505 CONDIT DRIVE ROOF REPLACEMENT & 6 AVIATION CENTER ROOF REPAIR
Village of Rantoul
#VRNTL-18-B-03

ADDENDUM #1

Item 1. Revised Scope of Work

SKETCH2 - Main Level

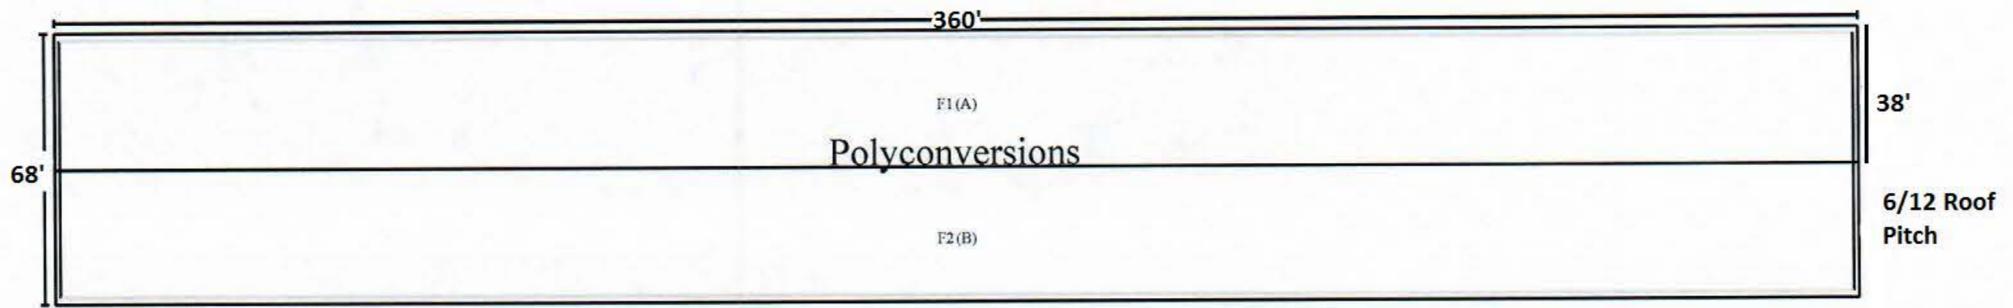
6 AVIATION CENTER ROOF REPAIR

Item No.	Description	Quantity	Unit Price	Amount
1	Remove/Dispose & Replace 7 standing seem metal panels.	560SF		
2	Detach and reset 7 panels above the damaged panels.	560SF		
3	Install Paper faced Insulation	560SF		
4			TOTAL:

NOTE: See Roof sketch page 2
